## **Volvo S 40 / V 40 model year 1998/99 / 2000 with petrol engine**

### **Ticking noises from engine bay.**

Bulletin

Picture 1

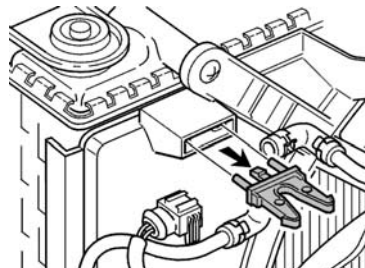
- Remove the hoses and the connector from the solenoid valve (fitted on the left side of the fan cover).
- Remove the solenoid valve from the bracket (Pic.1).
- Remove the bracket from the fan cover and dispose of it (Pic.2).
- Fit the new bracket, with the rubber insulation, to the solenoid valve (Pic3).
- Screw the solenoid valve with the bracket to the fan cover (use the right hole of the old bracket Pic.4).
- Refit the hoses and connector to the solenoid valve.
- Check for function and leaks.

Picture 5

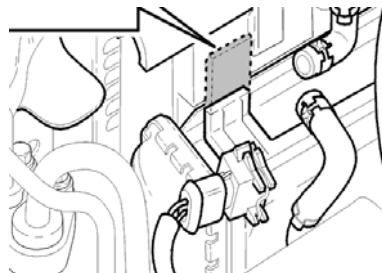
- Remove the cover from the radiator.
- Remove the hoses and the connector from the solenoid valve (Pic.5).
- Remove the solenoid valve from the bracket (from vehicle model year 98/99 up to chassis number: ...414999 the solenoid valve must be renewed. Since model year 2000 and chassis number: 415000... only the bracket must be changed).
- Cut the upper end of the old bracket (Pic.6).
- Fit the new bracket with rubber insulation to the solenoid valve (Pic.7).
- Screw the solenoid valve with the bracket to the existing screw of the intercooler (Pic.8). Refit the hoses and connector to the solenoid valve. Please ensure that the clips of the switching valve hoses do not scrub the air intake hose.
- Check for function and leaks.
